TECHNICAL NOTE

Project Title: Land South of Grevatts Lane/ A259

Report Reference: JNY10830-07

APPLICATION REF: M/16/22/PL – WSCC HIGHWAY AUTHORITY COMMENTS

Status	Drawn By	PM/Checked by
PRELIMINARY	AJ	MA
Project Number	Scale @ A3	Date Created
JNY10830	1:1500	07/04/22
RPS Drawing/Figure Number		Rev
JNY10830-18		A
rpsgroup.com

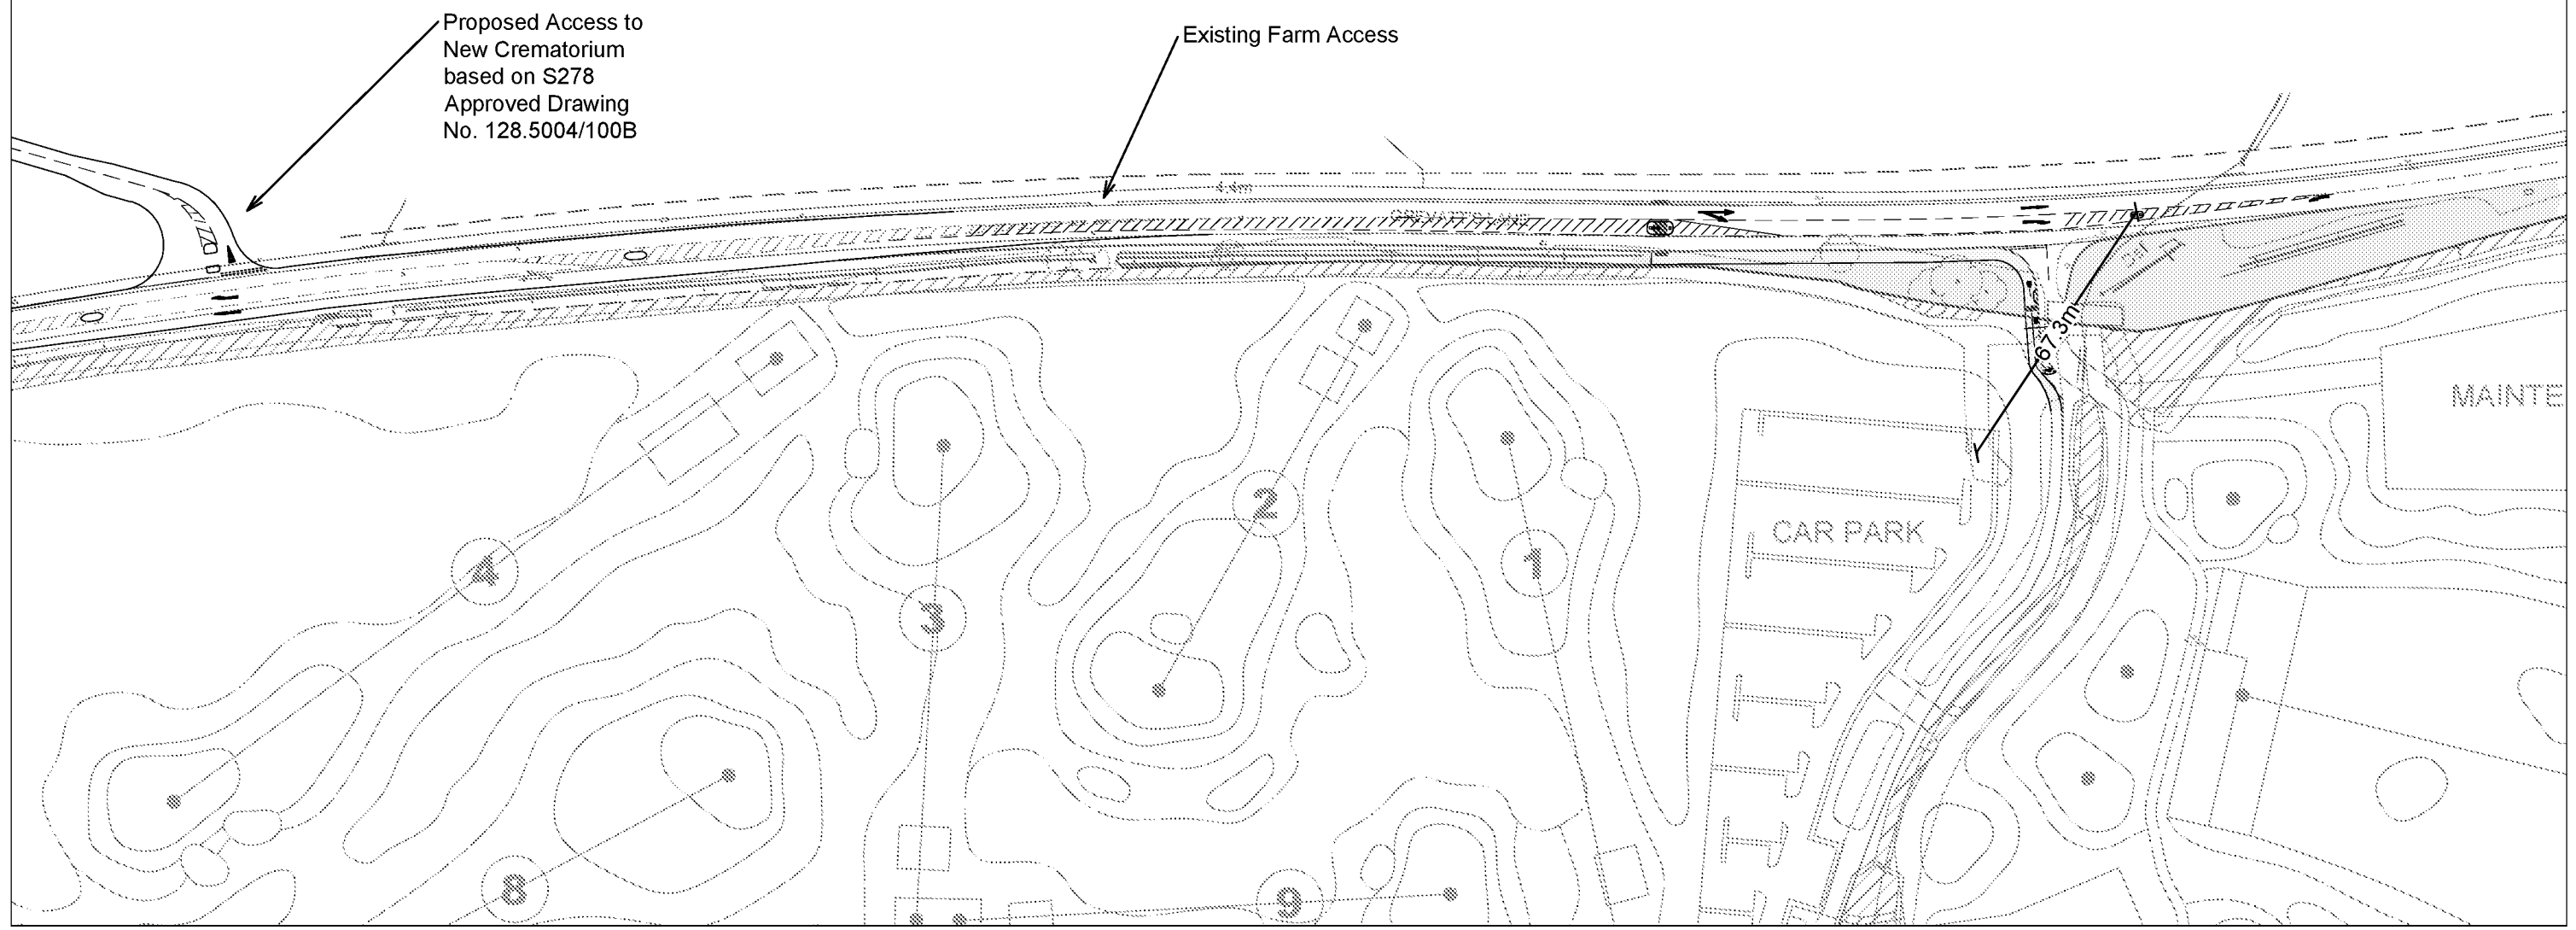
- 1.1 The proposed arrangement takes on board the comments raised by the Road Safety Auditor as well as including the extent of works proposed as part of the Crematorium access proposals to the west of the site. The layout including the Crematorium access is included in **Appendix 1**.

Road Widths amended following comments from WSCC				
MA				11.05.22
Rev	Description	By	CB	Date

Status	Drawn By	PM/Checked by
INFORMATION	AJ	MA
Project Number	Scale @ A1	Date Created
JNY10830	1:1000	06/01/22
RPS Drawing/Figure Number	Rev	
JNY10830-13	C

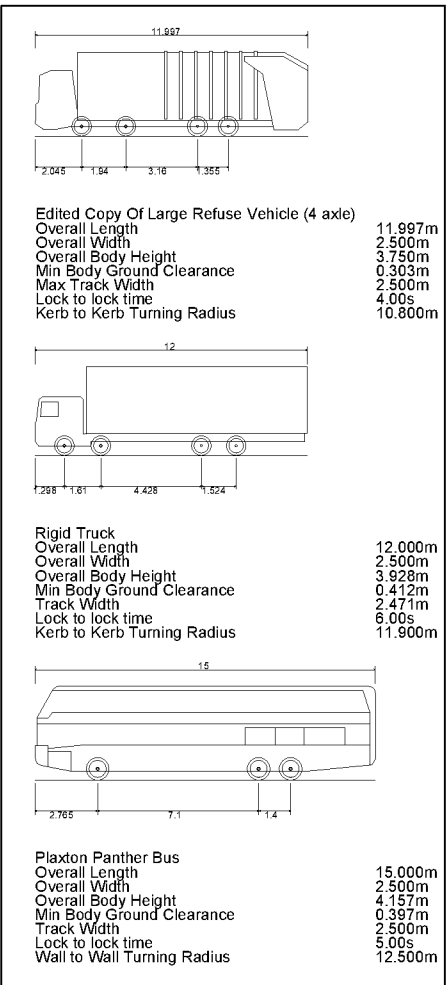
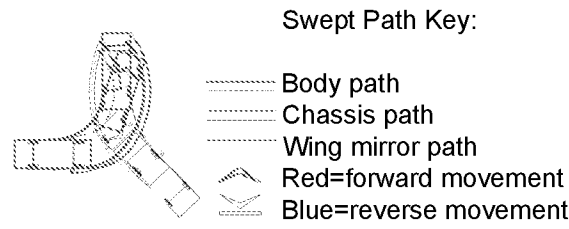
- 1.28 *Bus and coach parking (and waste and serving requirements) - None has been shown. Applicant to provide details of such uses/requirements and plans showing access, parking and turning arrangements for such vehicles.*
- 1.29 The Club has advised that the site is expected to not have more than one coach accessing the site at any one time and that this would be a very infrequent occurrence, possibly once a month. The proposal includes a lay-by within the maintenance area for the coach to wait. The tracking of a coach is included in **Appendix 5**.

C	Latest layout added (Z0624-NOV-V4-XX-M3-A-0001_Site_220422)	AJ	MA	26.04.22
B	Coach tracking re-routed and layby added	AJ	MA	07.01.22
A	Coach tracking re-routed	AJ	MA	06.01.22
Rev	Description	By	CB	Date
